Grey Close

Covering Statement for Non-Material Amendment

Hickman & Smith Architects

This covering document outlines the changes proposed for a non-material amendment to the previously approved householder application 22/00214/HOU.

Proposed Amendment to Front Elevation

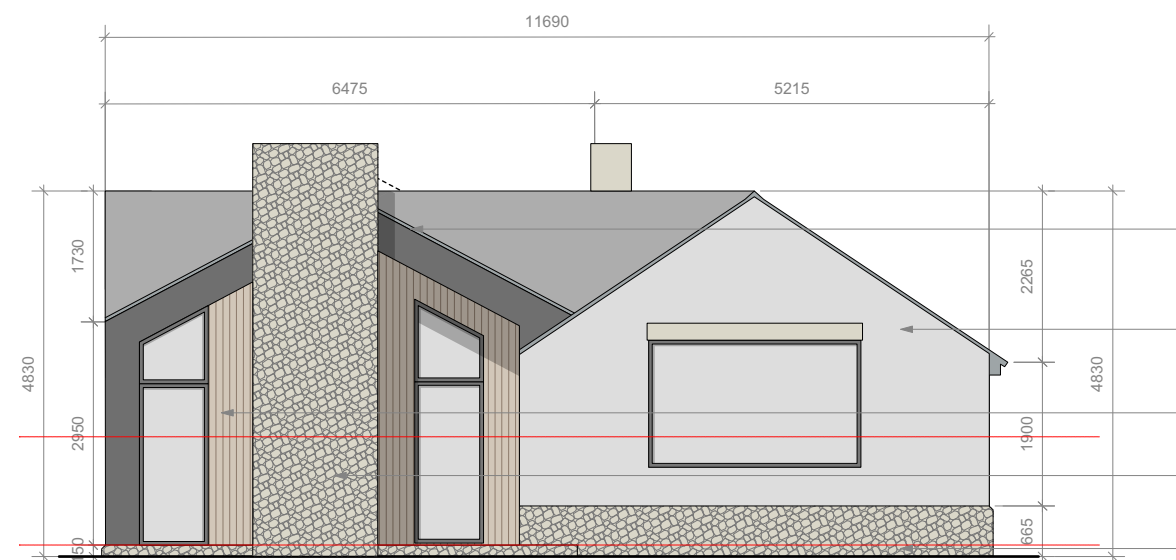
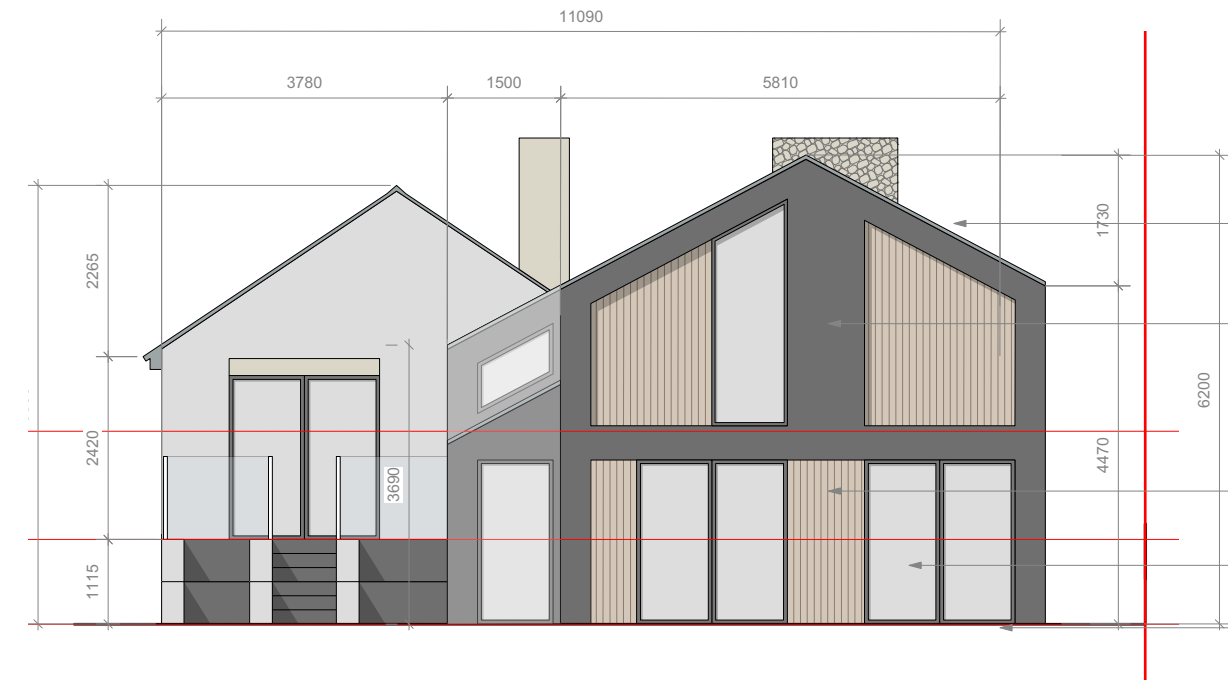
The width of the side extension from the front elevation has been slightly reduced and the materials used on the new gable have been amended from light render to dark render with timber clad infill.

Proposed Amendment to Rear Elevation

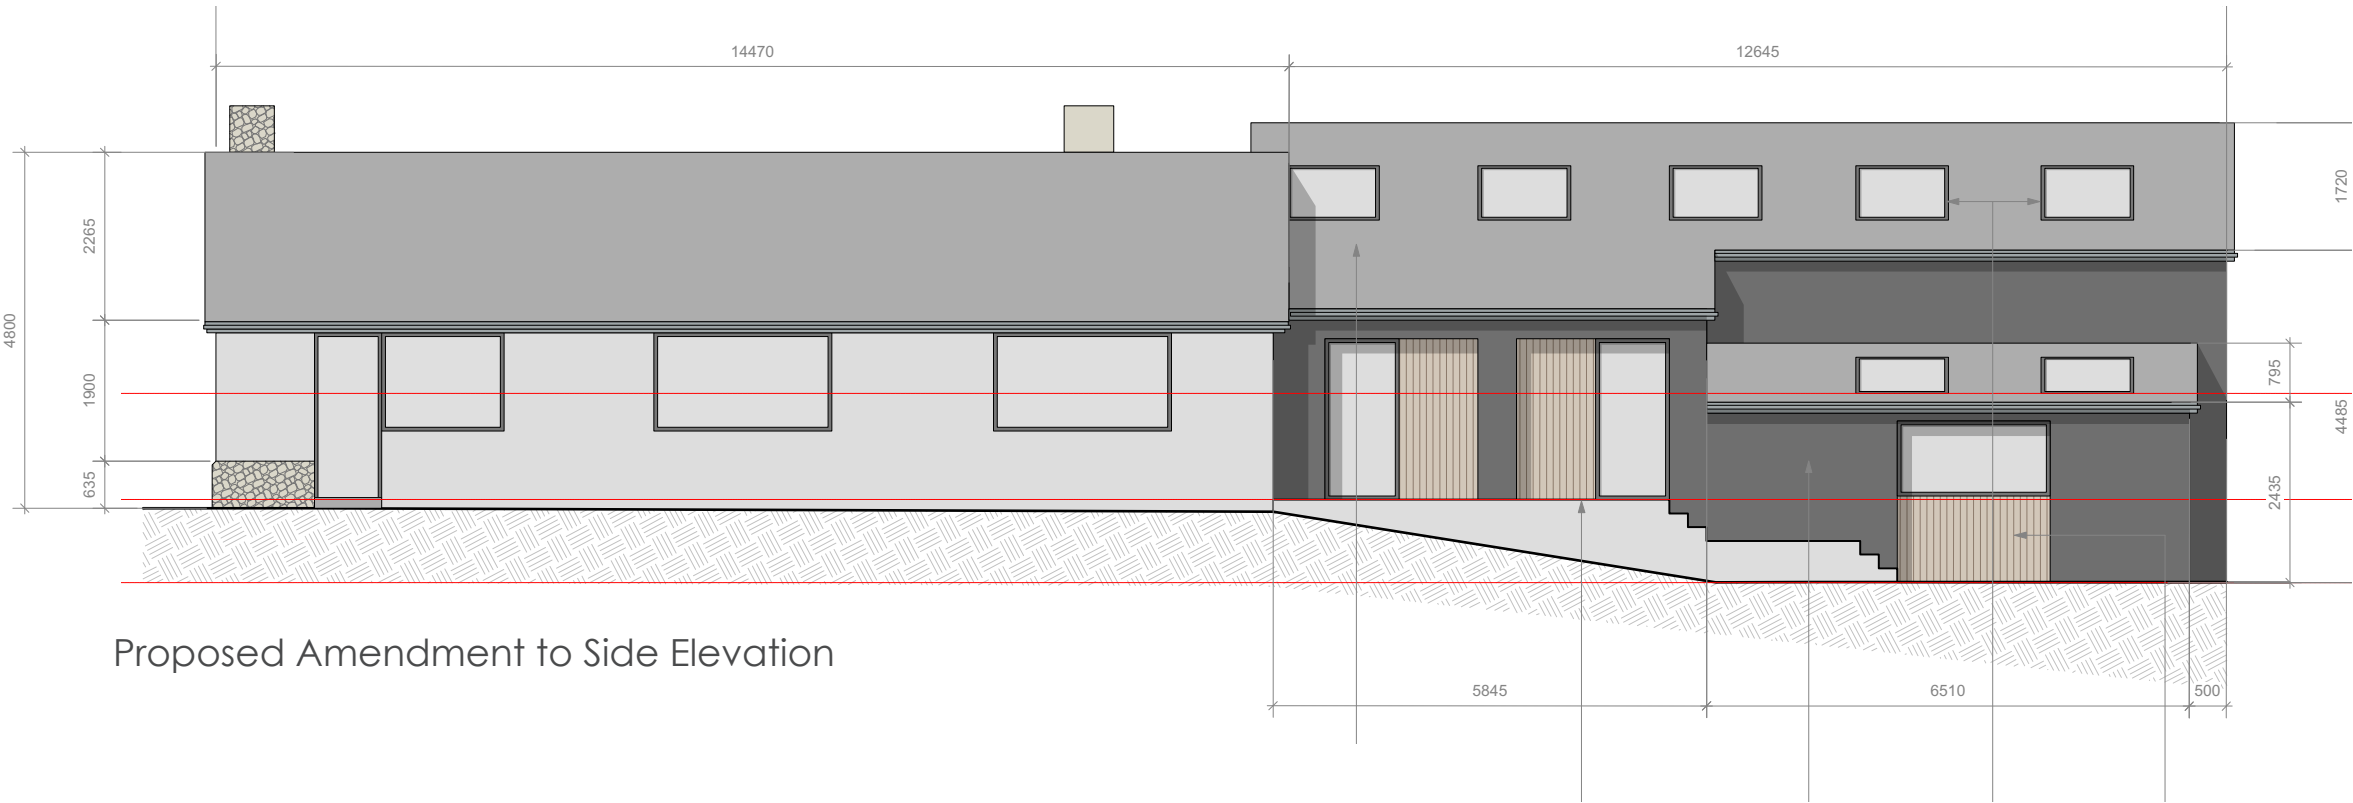
The width of the new rear gable has been slightly reduced and massing has been amended with additional single storey elements. The basement element has been reduced and the terrace has been changed to stepped landscaping. The materials used on the new gable have been amended from light render to dark render with timber clad infill, and there have been some changes to the fenestration of windows.

Proposed Amendment to Side Elevation

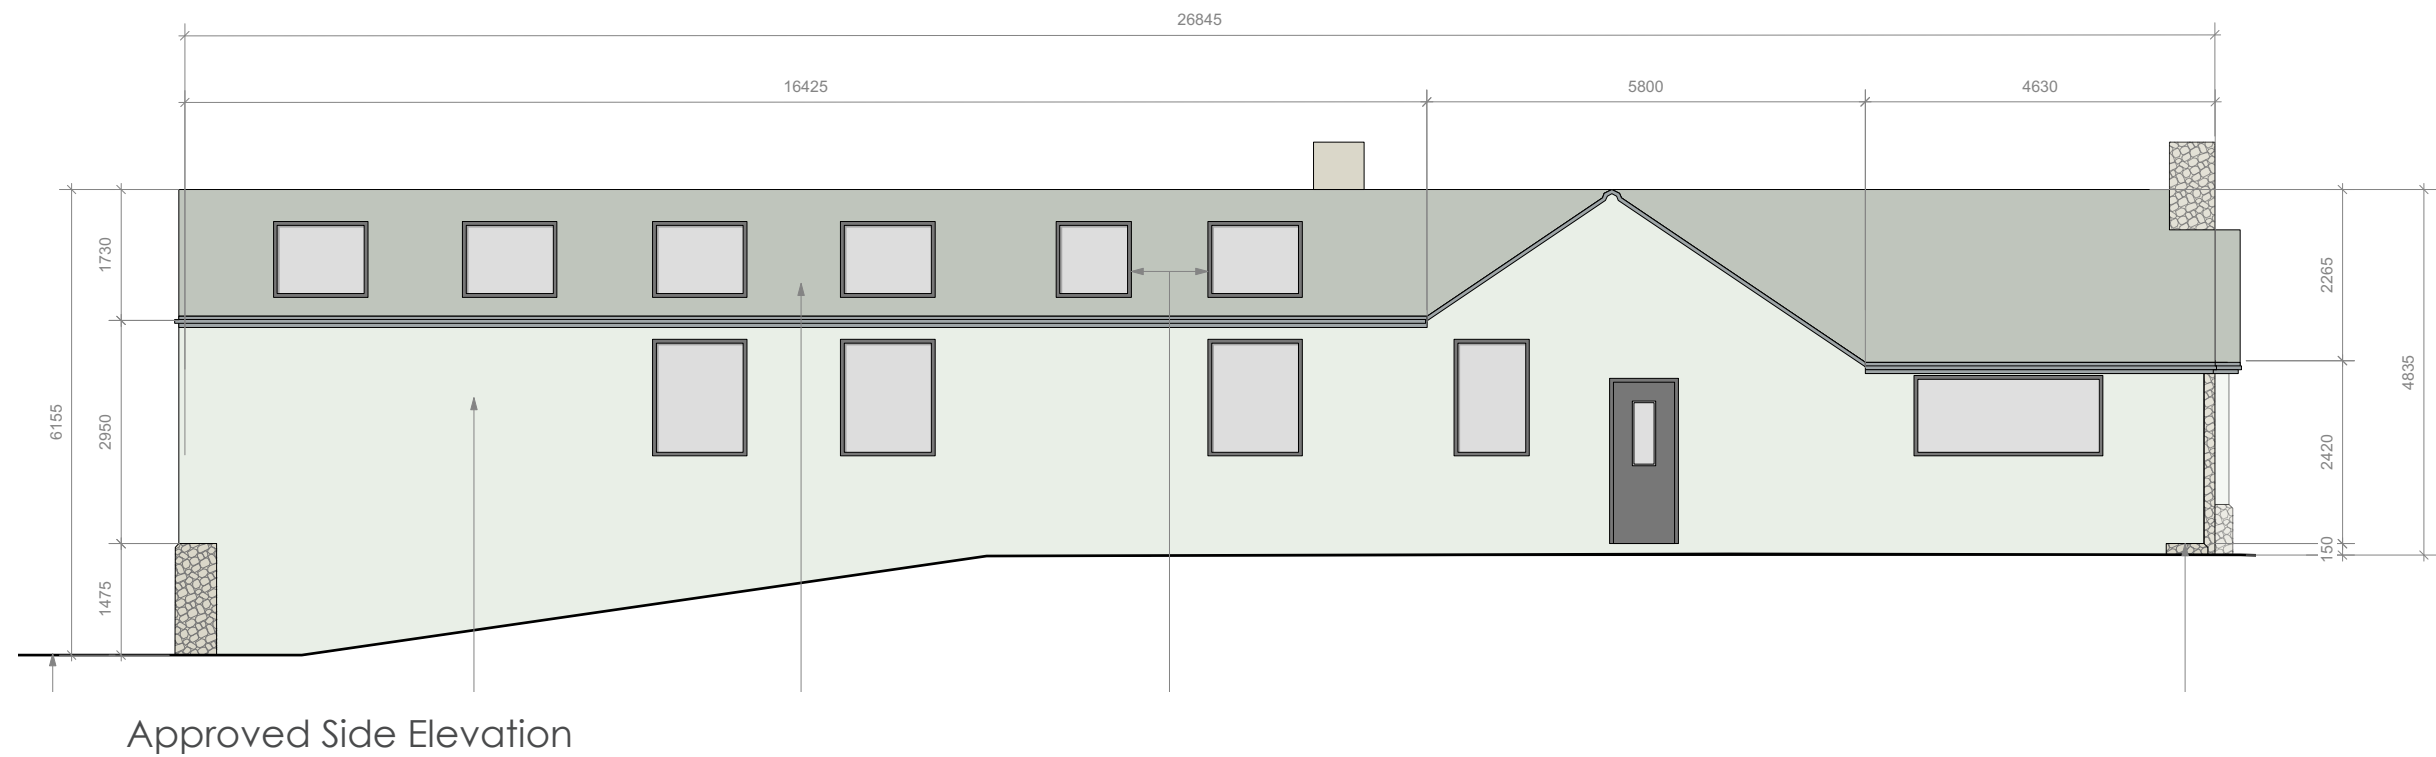
The rear projection massing has been amended to show stepped landscaping instead of the approved higher level terrace. Some single storey additions have been added and the materials have been amended.
